## ADDENDUM NO. 2

TO: PLANS AND SPECIFICATIONS FOR STATE OF MISSOURI

REPLACE ROOF  
PROFESSIONAL REGISTRATION STATE OFFICE BUILDING  
JEFFERSON CITY, MISSOURI  
PROJECT NO.: O2006-01

9A  
A-302

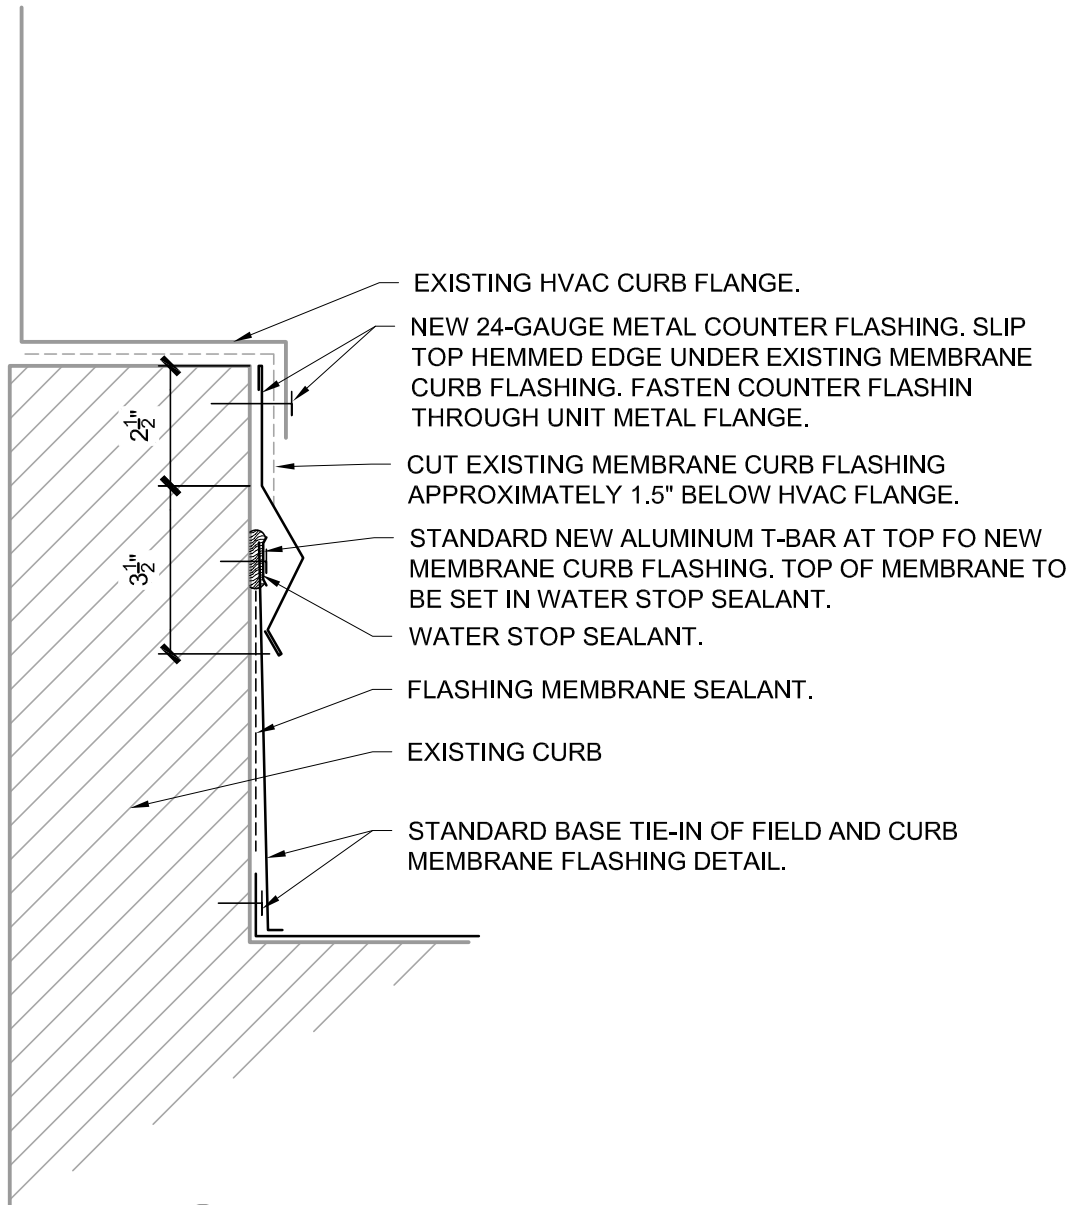
- a. ADD Section Detail 9A/A-302 on attachment A-302-R1:
  - Detail shows curb flashing at some existing RTU's. Verify warranty acceptance from TPO Roof Membrane Manufacturer.
  - RTU's are not required to be removed and reset, but need to be flashed to meet manufacturer's requirements for warranty.
- b. REVISE Detail 3 – Roof Vent Flashing as follows:
